Re: WDNR Water Resources Application for Project Permits – Data Request Response

February 1, 2021 WDNR L5WSRP Data Request Response

Additional Response – June 2021

Data Request Question #4:

Line 5 Relocation Rev1 - HCA Could-Affect Segments

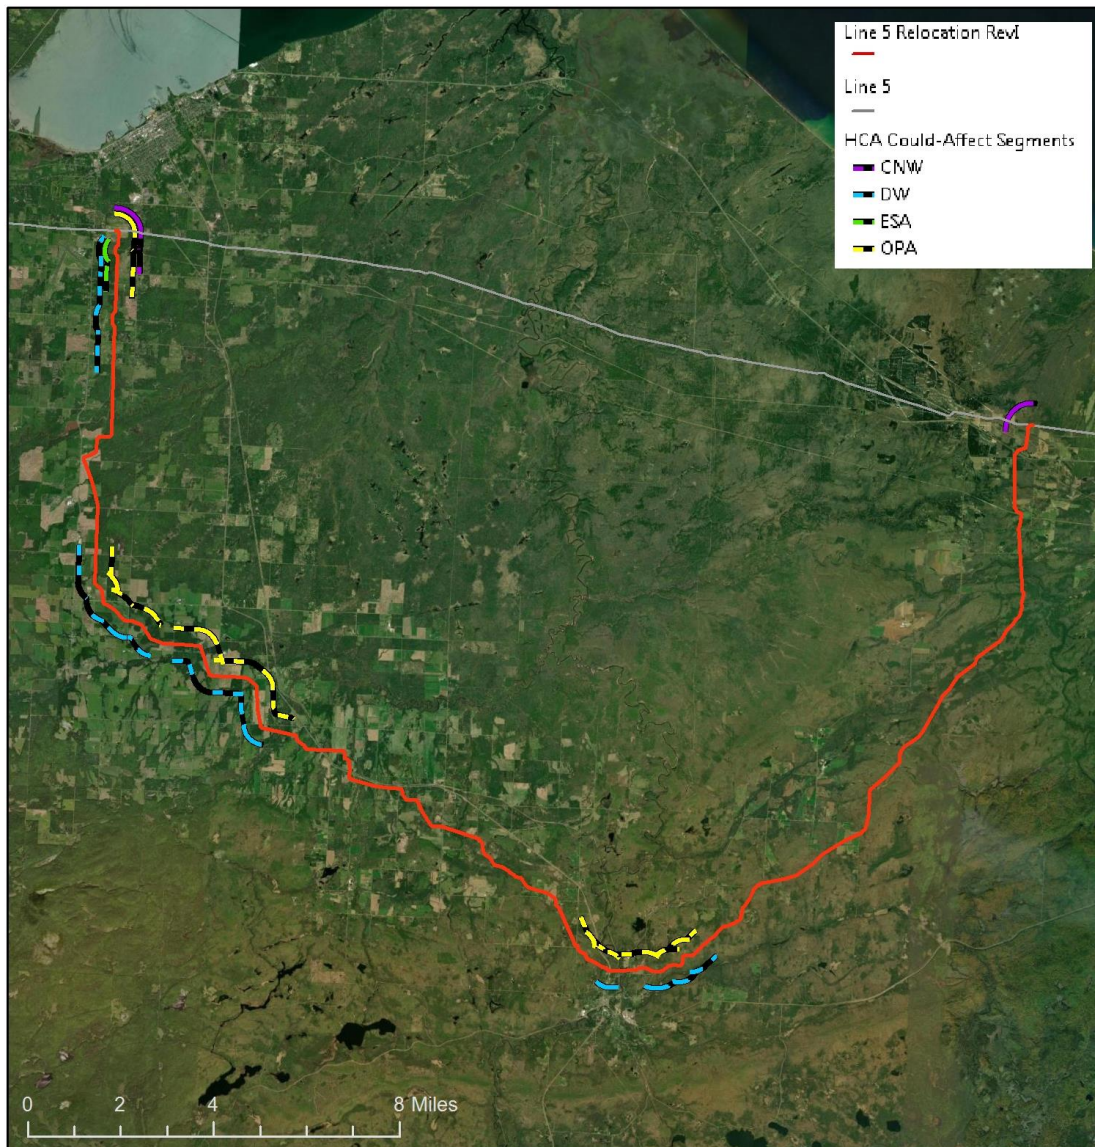
- vii. state is an Emergency Flow Restriction Device (EFRD) analysis was conducted on the reroute.
 - viii. indicate the location on a map where the pipeline could leak into HCAs and/or USAs with the maximum drain-down volume.

- ix. indicate locations on a map of where HCA's and/or USA's could be impacted by the worst case release.
- c. Summarize how the proposed 41-mile reroute of Line 5 would compare to the existing 12-mile segment of Line 5 in terms of:

The map below shows the proposed relocation route, with the segments of pipe that could potentially impact an HCA either directly or indirectly highlighted with color-coded offsets. Due to the sensitive

nature of the HCA data, we are unable to display the HCA polygons themselves on this map (e.g. the location of drinking water intake protection areas, habitat ranges of species at risk, etc.).

Although not indicated on the map, the majority (**94%**) of the HCA segments are indirect/transport could-affects. That is to say that although the pipe itself is not within an HCA polygon, spill plumes modeled from these segments (using maximum calculated volume out) travel downhill or downstream into an HCA polygon. Only a small portion (~1 mile) of the relocation segment directly intersects an HCA. This segment is located near the beginning of the proposed relocation.

The determination of HCA could-affect segments is based on spill plumes modeled using the maximum potential release volume at any given point along the pipe, which represents a worst-case release scenario. Therefore, the terms “worst-case release” and a “maximum drain-down release” scenario are synonymous. The map submitted for 4.b.viii indicates the location of segments of pipe that could impact HCAs as a worst case release scenario from a volume out/spill plume perspective using the maximum calculated drain-down volume.
